MEMO

To: Kristopher Byrd, Well Construction and Compliance Section Manager
From: Travis Kelly, Well Construction Program Coordinator
Subject: Re-Review of Water Right Application G-18746
Date: February 4, 2021

Groundwater Application Review Summary Form

PUBLIC INTEREST REVIEW FOR GROUNDWATER APPLICATIONS

Figure 4. Stream Depletion Model Results (Hunt, 2003)

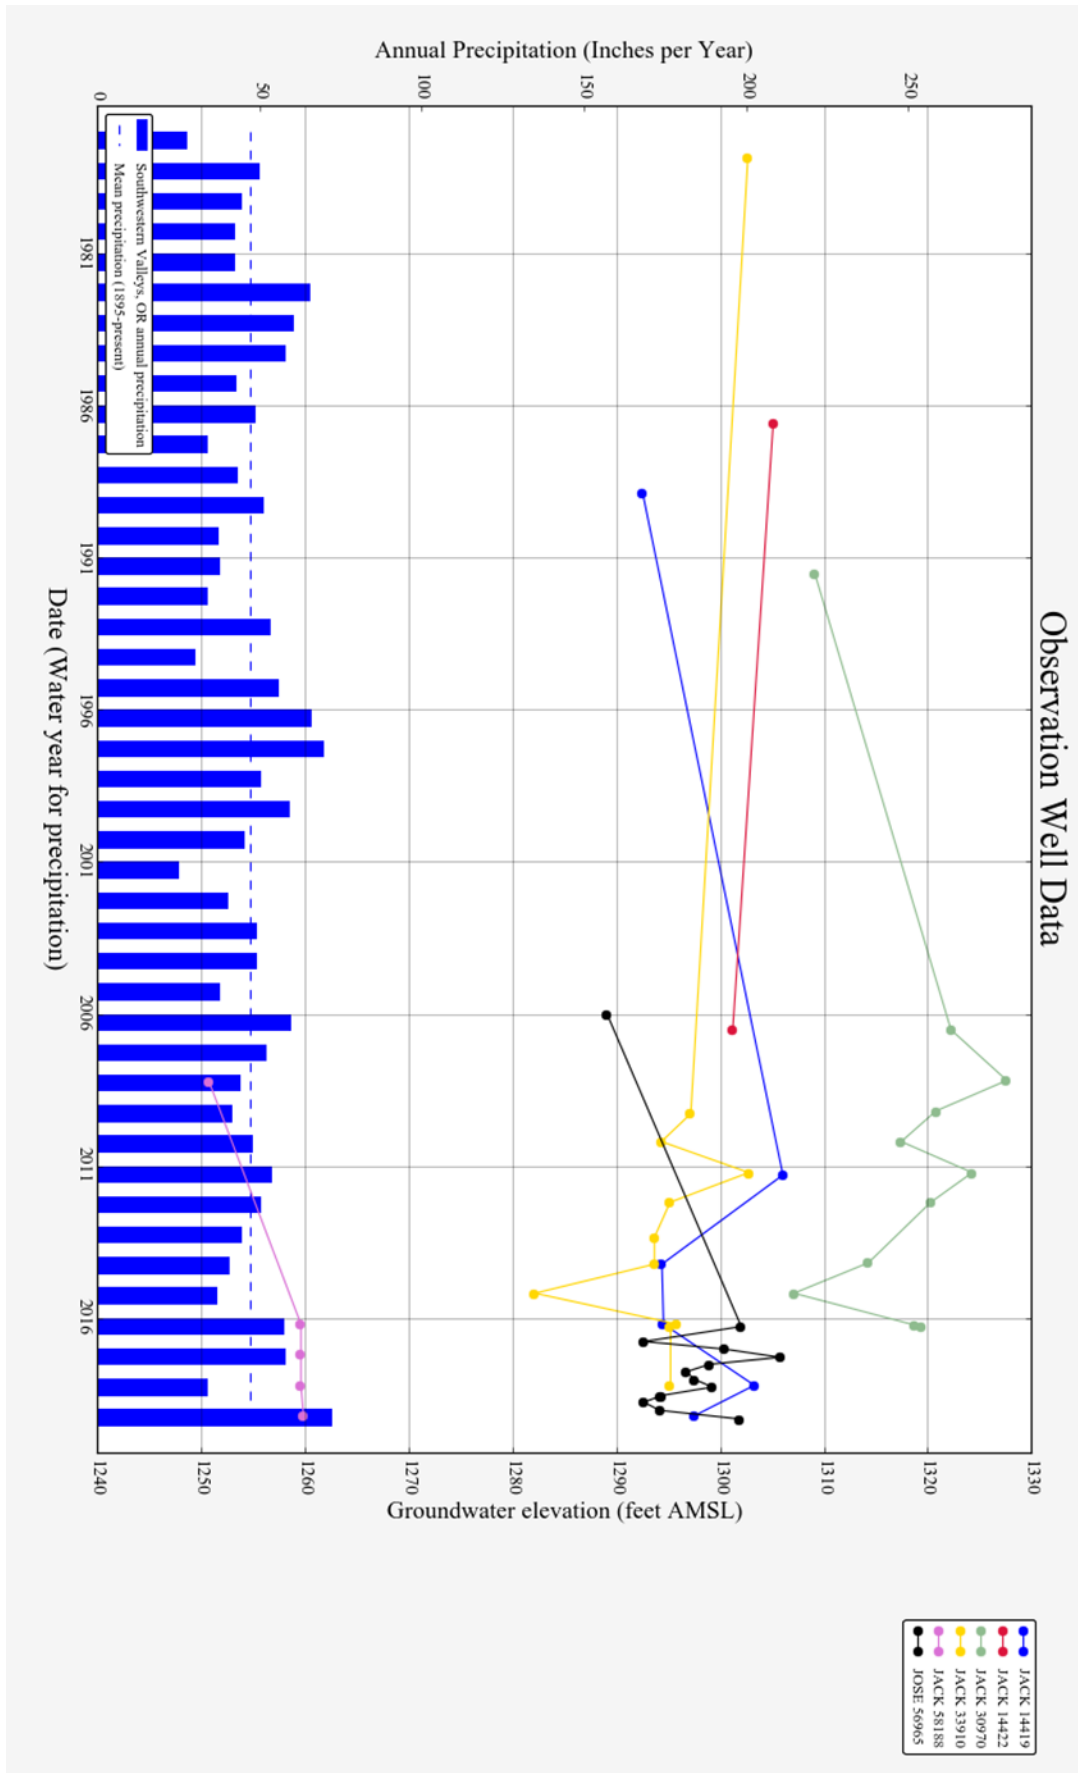
Comments: Streamflow depletion is estimated using an analytical stream depletion model (Hunt, 2003) using bulk aquifer parameters representative of the local geology. Model parameters and results for the closest well-stream combination are shown in Figure 4.
